ADDENDUM NO. 1

**EDGEMONT SCHOOL DISTRICT
GREENVILLE & SEELY PLACE SCHOOLS
HVAC UPGRADES AND CAFETERIA RENOVATIONS**

DATE: January 24, 2023

This Addendum consists of three (3) Pages, Sketch SK-A1.0, revised drawings GVES M200, GVES E101, SPES MD100, SPES M100, SPES M101, SPES M102, SPES M103, SPES M104, SPES M200, SPES M203, SPES M300, SPES M400, SPES ER100, SPES ER104, SPES E100, SPES E103, and SPES E104.

1-24-2023	ADDENDUM 1
1-06-2023	BID
DATE	ISSUED TO
SHEET SIZE 30"x42"	DRAWING NO. SPES ER100
SCALE AS NOTED	FILE NO. 21434.01
DRAWN BY LFG

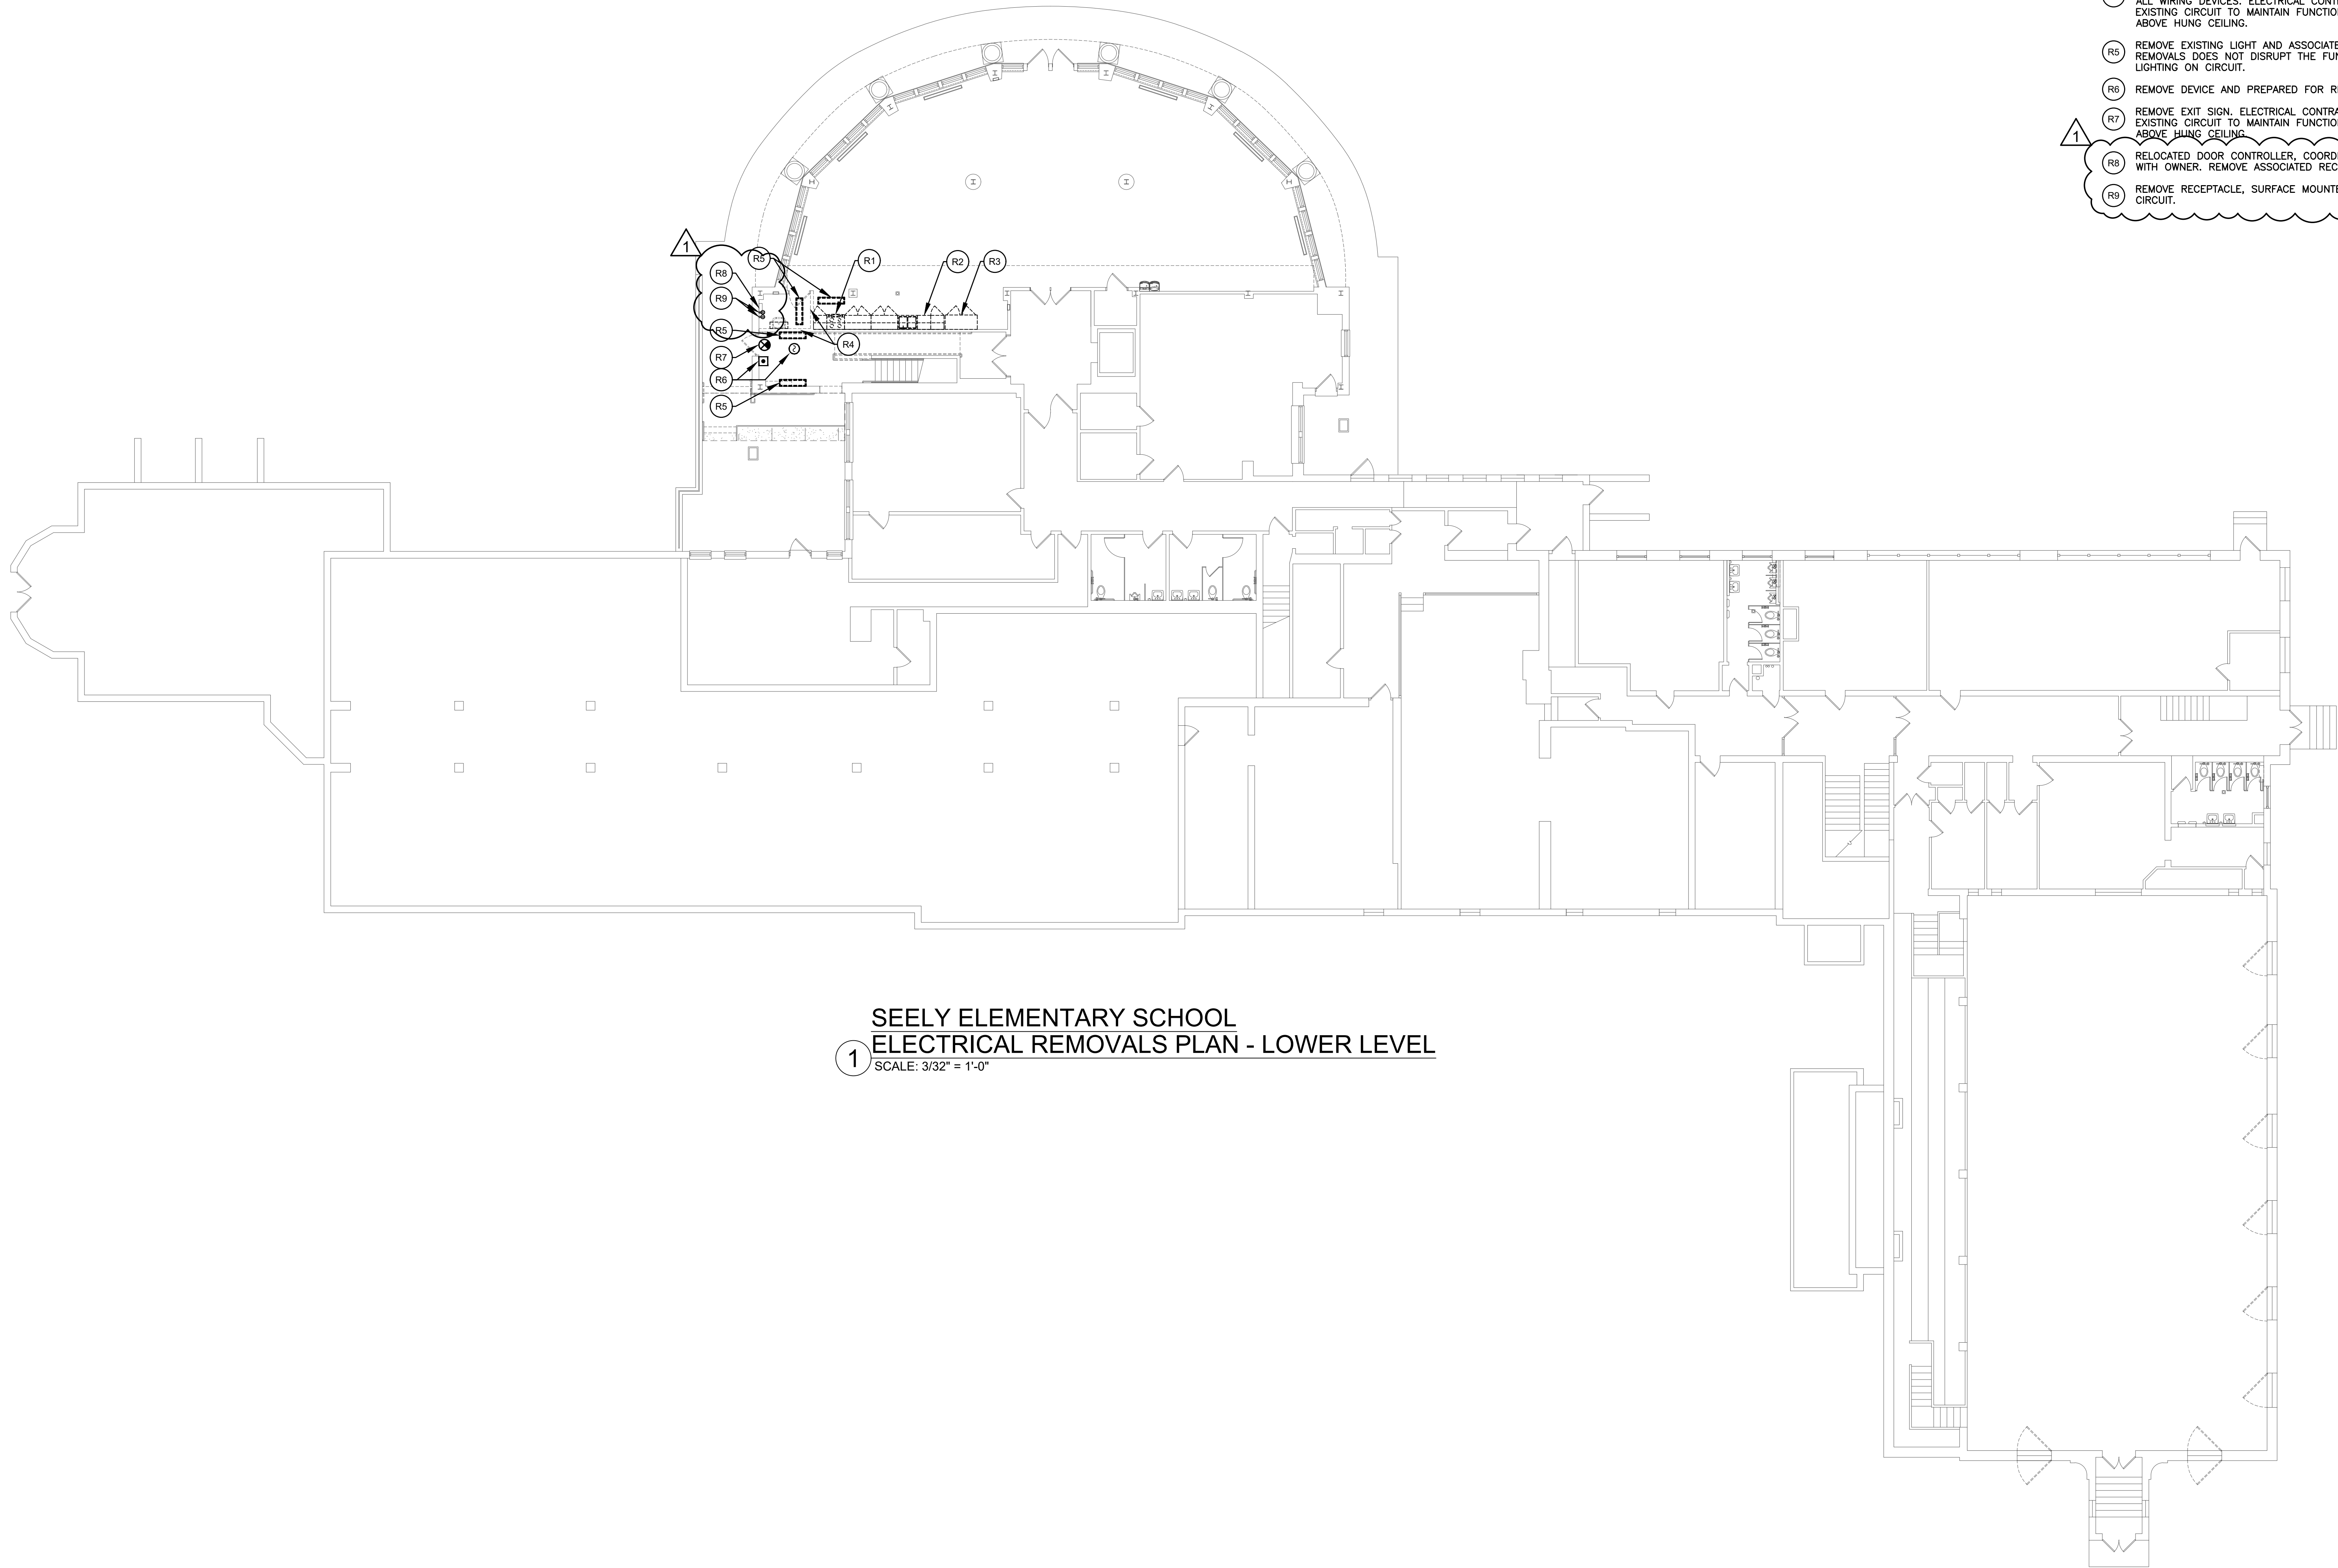
DRAWING SPES ER100 – BASEMENT ELECTRICAL REMOVALS PLAN

ADD removals and notes as shown on drawing attached to this addendum.

1-24-2023	ADDENDUM 1
1-06-2023	BID
DATE	ISSUED TO
SHEET SIZE 30"x42"	DRAWING NO. SPES ER104
SCALE AS NOTED	FILE NO. 21434.01
DRAWN BY LFG

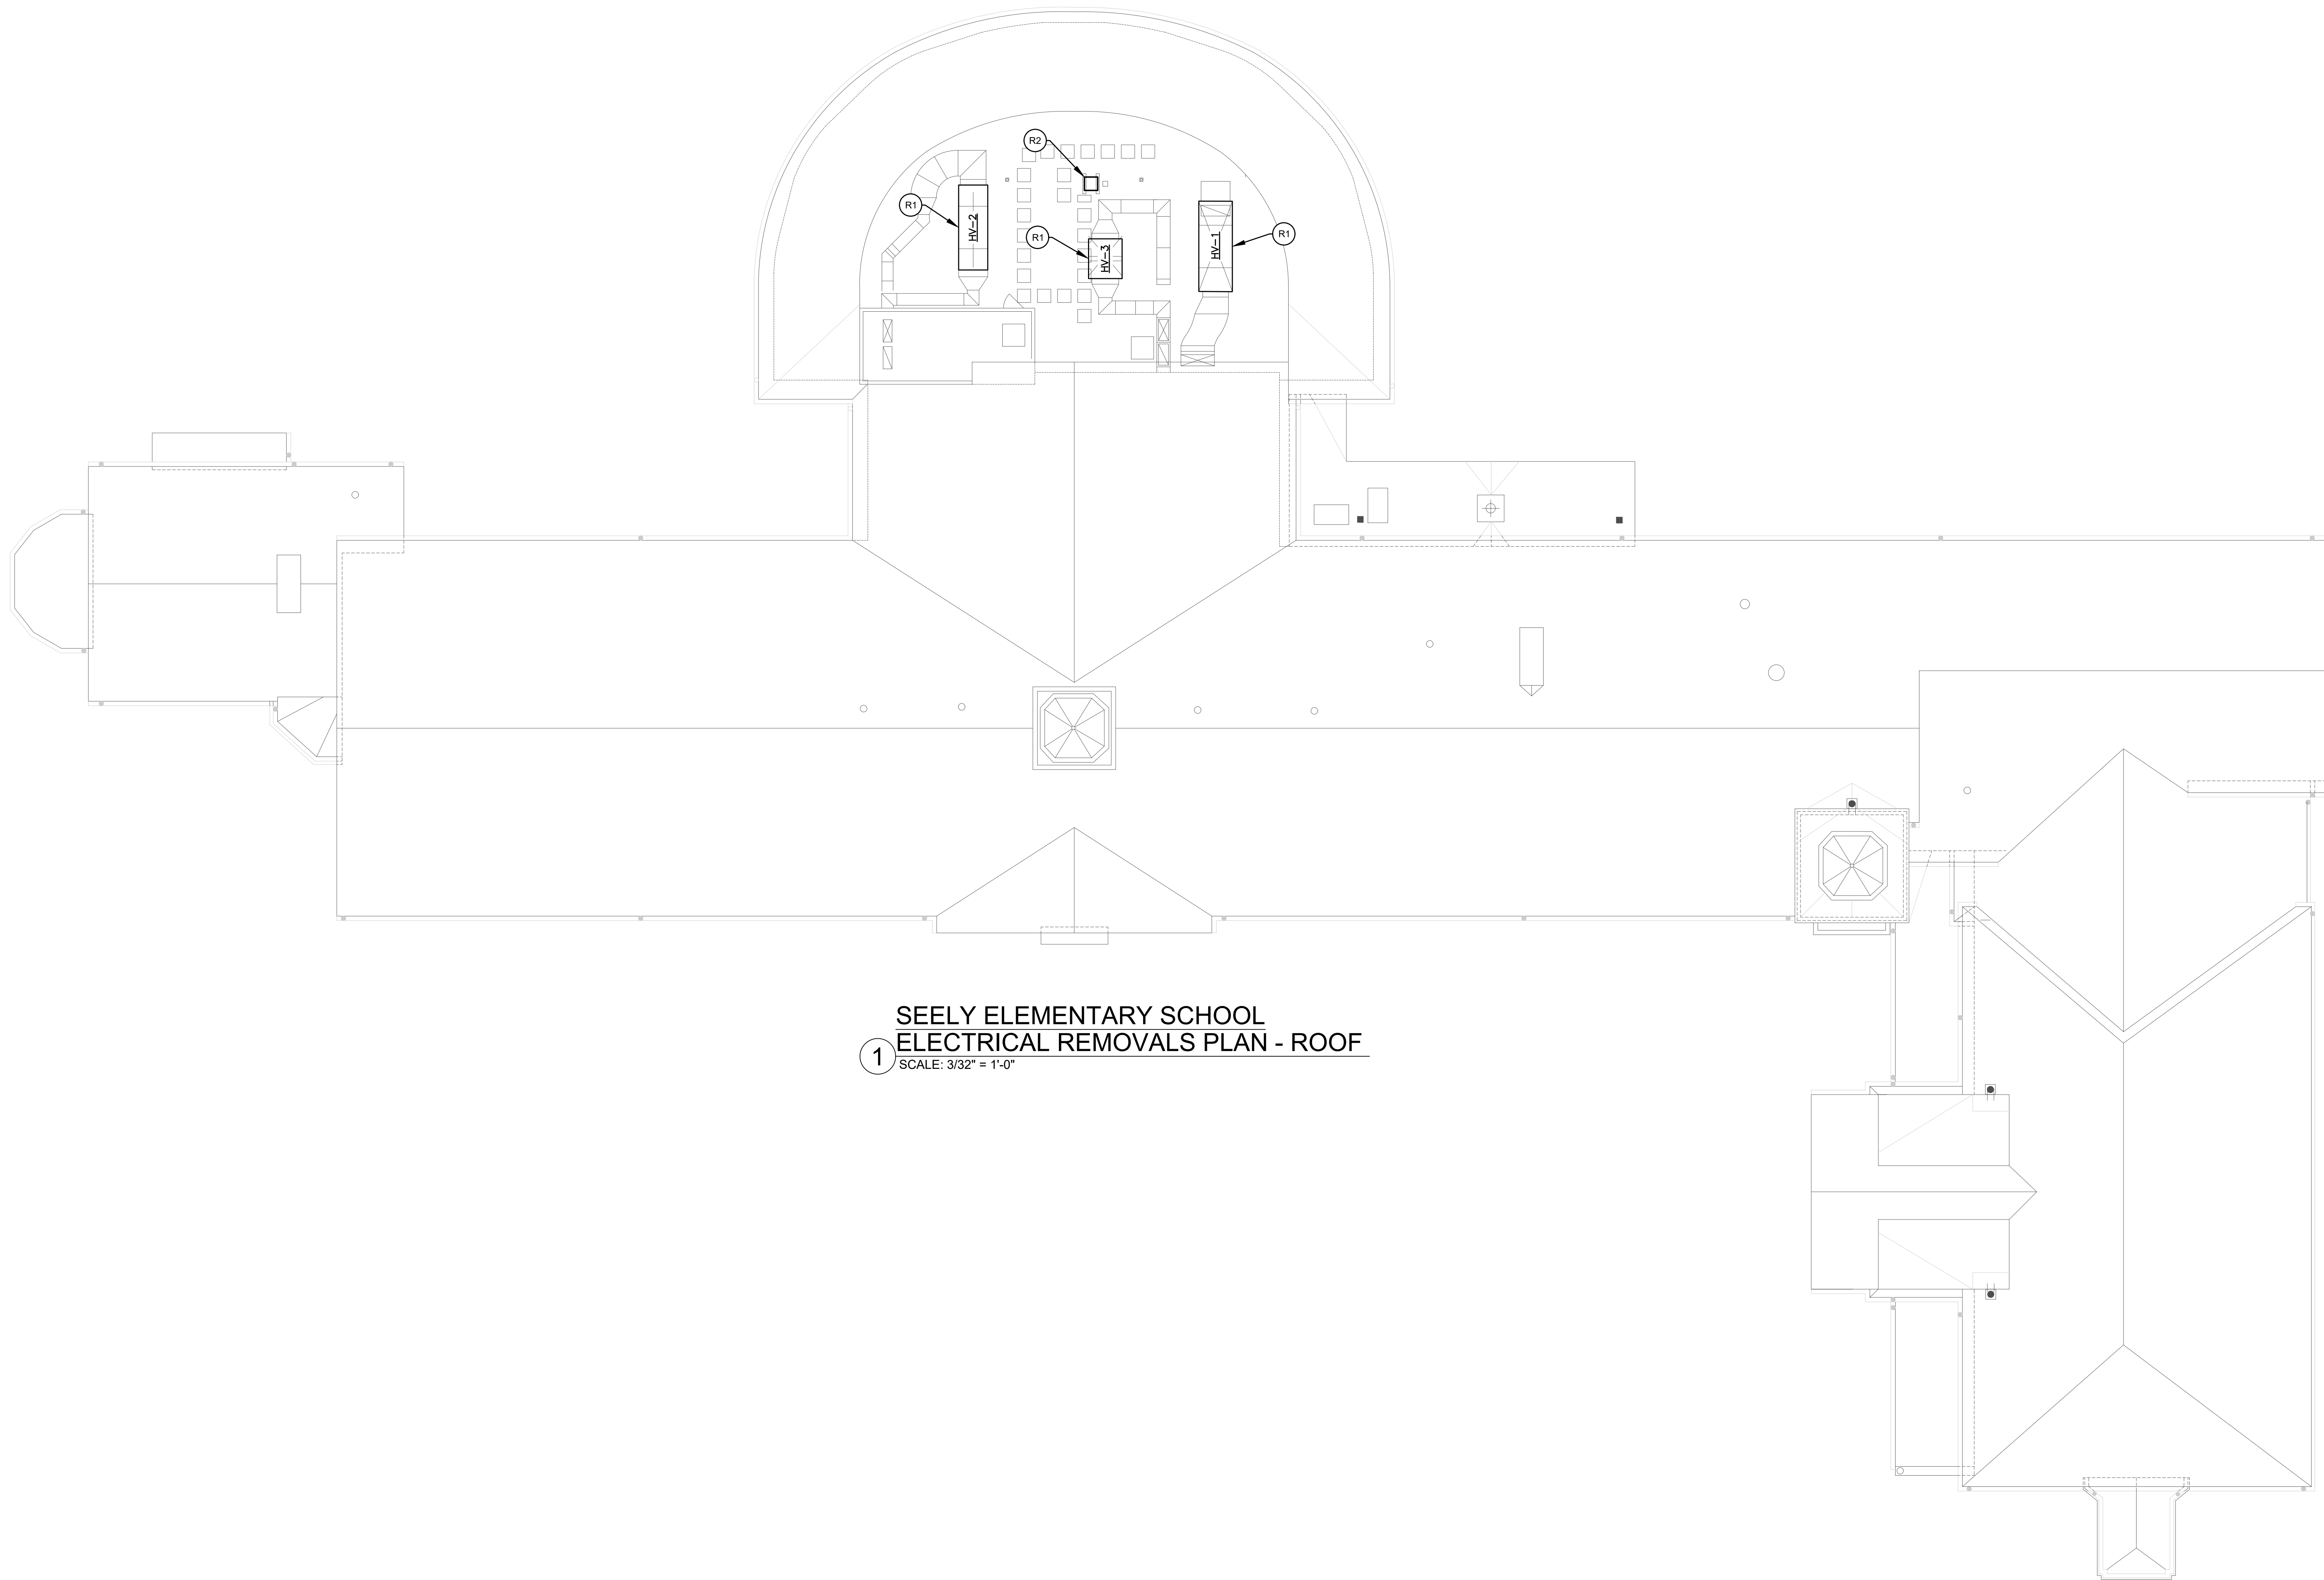
DRAWING SPES ER104 – ROOF ELECTRICAL REMOVALS PLAN

REVISE removal note R1 as shown on drawing attached to this addendum.

- 1 REMOVAL NOTES:
- R1 ELECTRICAL CONTRACTOR SHALL REMOVE UNIT, DISCONNECT AND CIRCUIT BACK TO PANEL "HVAC-1". REMOVE ANY ASSOCIATED DUCT SMOKE DETECTORS AND CONTROL REALYS.
- R2 ELECTRICAL CONTRACTOR SHALL ASSIST MECHANICAL CONTRACTOR IN MOVING EXISTING CONDENSING UNIT. MOVE, DISCONNECT AND CIRCUIT. RE-CIRCUIT FROM INTERIOR THROUGH NEW PIPE PORTAL, PROVIDE WIRING AND CONDUIT AS NEEDED.
